## ***Reactor EP 3D ARF Manual Addendum***

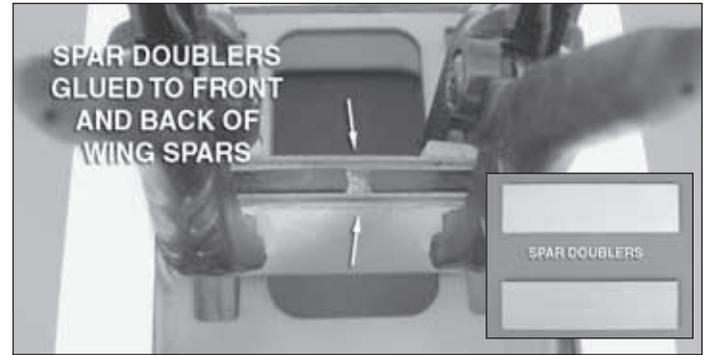
The design of the interlocking wing spars has changed slightly to make alignment much easier and quicker. The procedure in the manual on pages 9 and 10 for gluing the wing panels into the fuselage remains the same.

Step #6 on page 10 of the manual shows a single balsa spar doubler. Two spar doublers are now included instead of just one, and they are made of plywood instead of balsa. Coat one side of each spar doubler with epoxy as well as the front and back sides of the spars. Position a spar doubler on each side of the spars as shown and use clamps to hold them in place while the epoxy cures.
